Case #: PB 2014-01
Site: 181 & 197 Washington Street
Date of Decision: March 6, 2014
Decision: Petition Approved with Conditions
Date Filed with City Clerk: March 12, 2014

PLANNING BOARD DECISION

Legal Notice: Applicant CPI-SCC, LLC and Owners The Somerville Community Corporation, Inc and A&M Realty Trust seek a Special Permit with Site Review (SZO §5.2) to construct two mixed use buildings of approx 46,305 nsf and approx 38,040 nsf under §6.1.22.D.1 and §6.1.22.D.2. The uses include small and medium retail of approx 6,000 sf, 65 residential units per SZO §7.13.B, §7.13.C, & §7.13.E. The applicant seeks a Special Permit under SZO §5.1 to reduce the number of parking spaces SZO 9.13.F and 9.17.2.A, to share a driveway and access and shared parking per SZO §9.17.2.B. Article 13 Inclusionary Housing will apply.

Figure A. Vertical Articulation

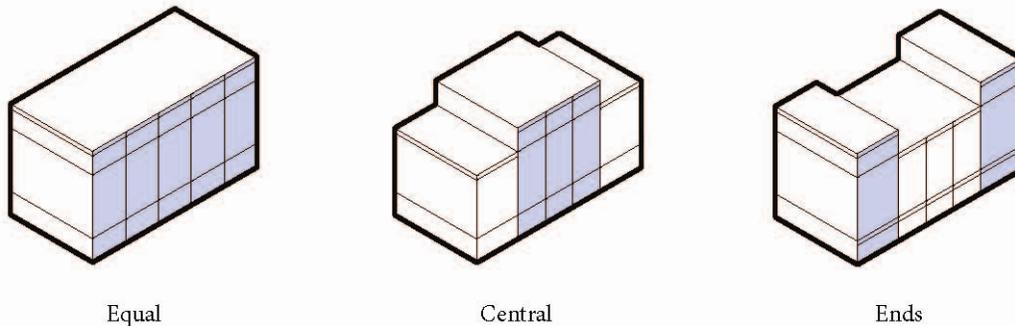
- i. The building will fill in approximately 265' of streetwall along Washington Street.
- ii. The massing and the height of the building are articulated in a manner that is compatible with the physical character of the mixed use buildings in the surrounding area. A rhythm to the building is established with a base, middle and top, with cornice lines and vertical accents to break up the building's massing. The Applicant has started an 'ends' approach (see below), similar to the guidelines of the recently approved Northpoint Zoning District. A condition of this report is that the Applicant complete this design element on the east end of the SCC building. Revised elevations shall be submitted for Planning Staff review and approval.

Flat facades have been avoided in a variety of ways. There are vertical accent bands to break up the length of the buildings including the condition above. The 4th floors use an accent material to create a 'top' to the building. There is a variety of materials including hardie artisan plank, metal panel, and storefront systems.
